STAFF REPORT COVER SHEET

Addresses:	127 – 133 Park St NE (Parcels 0382-52-0001, 0002, 0003, 0004, 005, 006, 0007, 0008, 0009, 0010, 0011, 0012)	Case Number:	PF-651311-CZ
Public Meeting Date:	12/5/2022	Applicant:	BFR Construction Company / Bukont Homes
Board/Commission:	Town Council	Owners:	Trustees of Vienna Presbyterian Church; Joseph T. Nocerino and Mary Ann Nocerino, Trustees; Ezra Partnership; Manufacturers Standardization Society of the Valve and Fittings Industry, Inc.
Existing Zoning:	T (Transitional)	Existing Land Use:	Office
Brief Summary of Request:	<p>Applicant requests:</p> <ol style="list-style-type: none"> 1. Change from Transitional zoning district to RM-2 Multifamily, Low Density 2. Site plan modifications of requirements for lot coverage, front yard setback, rear yard setback, and minimum lot area. 		
Site Improvements:	Applicant proposes to consolidate the twelve existing condominium parcels into one lot, raze the four existing three-story office buildings, and construct 24 single-floor residences in 12 individual two-family buildings. (Please note that the applicant has reduced these numbers from the prior proposal of 26 units in 13 buildings, which was reduced

Figure 3 - Illustrative plan showing suggested change by Planning Commission to remove building 14 to provide more open space shown in green and possibly rotate buildings 12 & 13 shown in red.

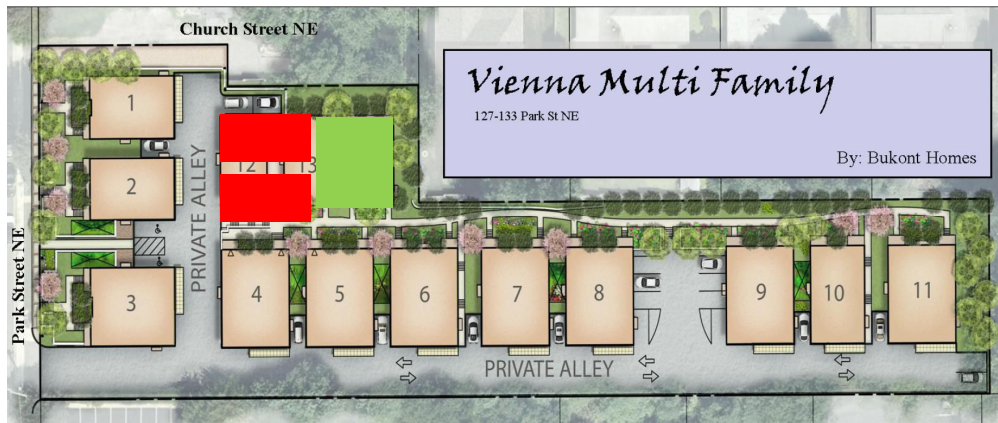
During discussions with the Planning Commission, the question was asked about removing another building to make room for more open space. If Building 14 were removed from the proposed development, approximately 1,265 square feet of lot coverage could be converted to shared green space. This would change the requested rear setback from 15 feet to the 20 feet required for Building 11. While converting this building to open space would serve to provide more shared open area for the residents, it would only reduce the lot coverage by 2%, compared to the proposal. The applicant has revised the concept plan to match the suggestion by some Planning Commissioners.
